RESIDENTIAL PLAN CORRECTION SHEET

ADDENDUM TO Permit No. 01684 - (1)  
Owner DAVE MULLHOLAND  
Contractor MIKE HUSTER MILLER  
Location 192 OLD CREEK DR,

ADDENDUM NO. 2 TO PERMIT NO. 01684

FOR 192 OLD CREEK DRIVE

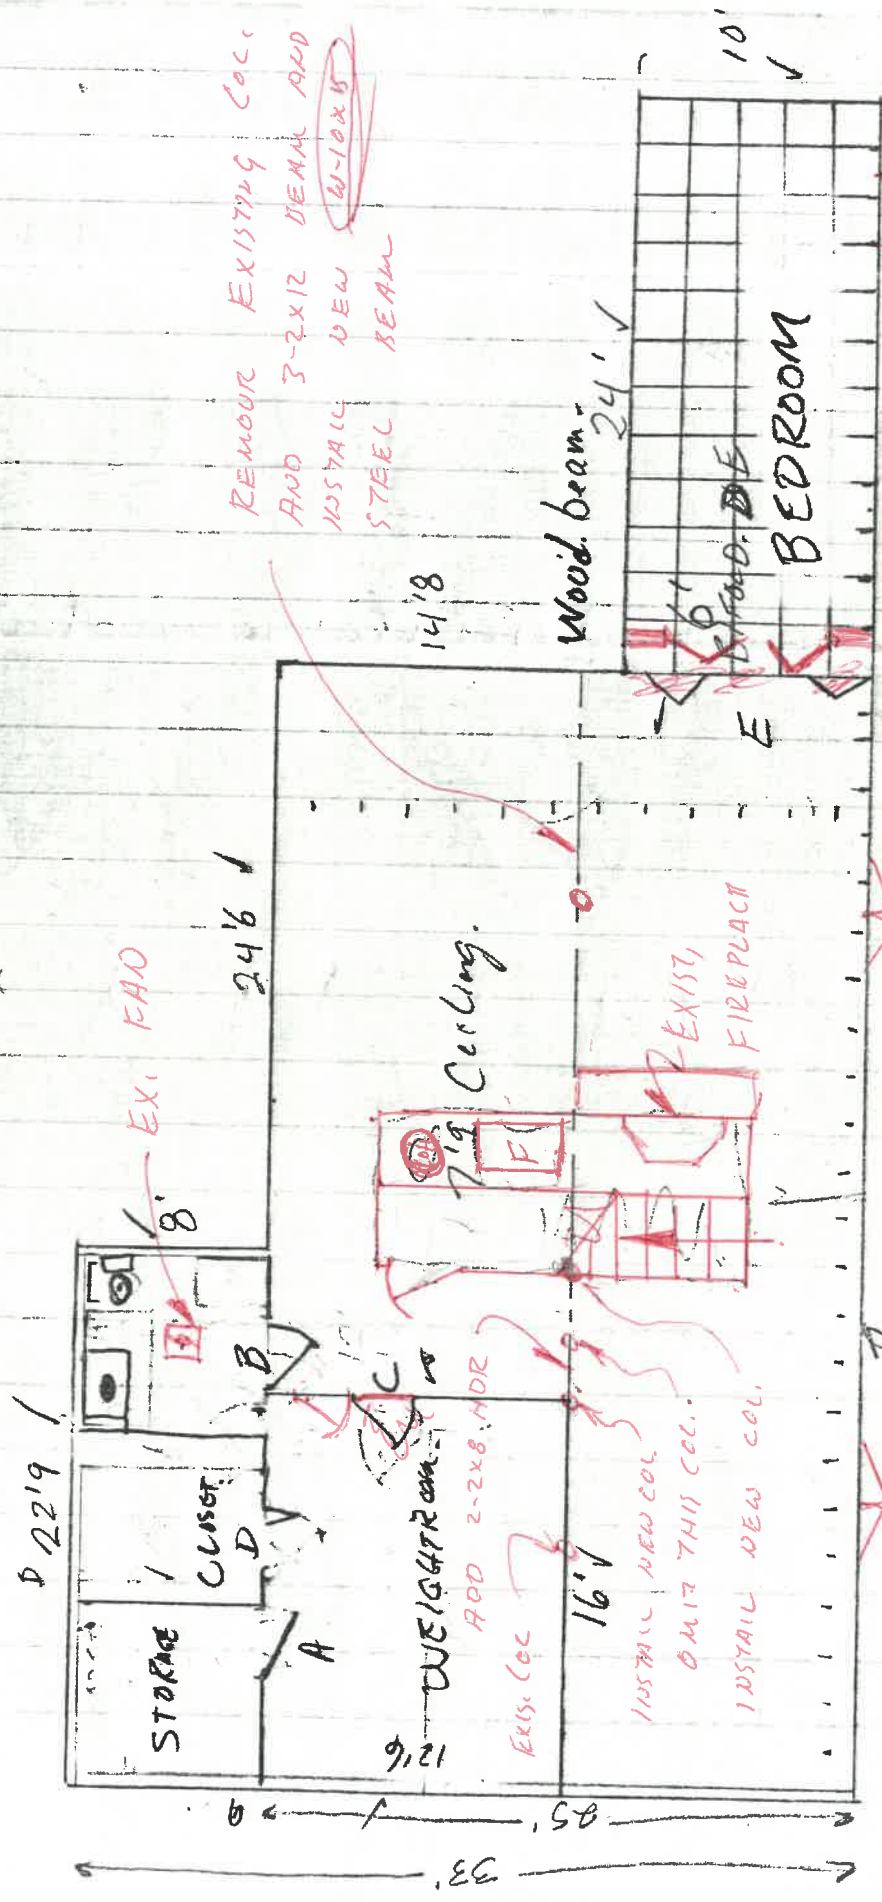
Additional Corrections. ALL SLEEPING ROOMS SHALL BE PROVIDED WITH EMERGENCY EXITS AS REQ BY C.I.A.D.O. SECTION R-211.2  
USE THE UNDERSIDE OF THE STAIRWAY WITH 5/8" FIRE SHIELD  
PLYWALL. PROVIDE A 2-2XB HEADER OVER THE HALLWAY NEXT TO THE STAIRS BEFORE REMOVING THE STEEL COLUMN.

Item No. 1 regarding removal of 2 columns, 1 east and 1 west of the fireplace.

- A. Span 6' +- in order to remove the column located in the hallway just east of the fireplace and stairway. This column can be removed if you install a 2 - 2 x 8 header. These 2 x 8's can be attached to the sides of the existing 3 - 2 x 12 beam and are required due to the joint in the beam above the column.
- B. Span 17' +- the column located in the living space west of the fireplace must remain due to the joint in the 3 - 2 x 12 beam above the column. The only alternative would be to remove the 3 - 2 x 12 beam and install a steel beam or lam. wood beam in its place which would be capable of supporting the main floor and attic loads imposed on the beam.

Item No. 2 - Since the natural gas fire furnace is located in the space below the stair, line the stair with 5/8" fire shield drywall tape and spackel the joints.

REMOVE EXISTING COL.  
 ADD 3-2X12 DEAN AND  
 INSTALL NEW W-10XB  
 STEEL BEAM

ADD 2-2X8 AND

OMIT THIS COL.

INSTALL NEW COL.
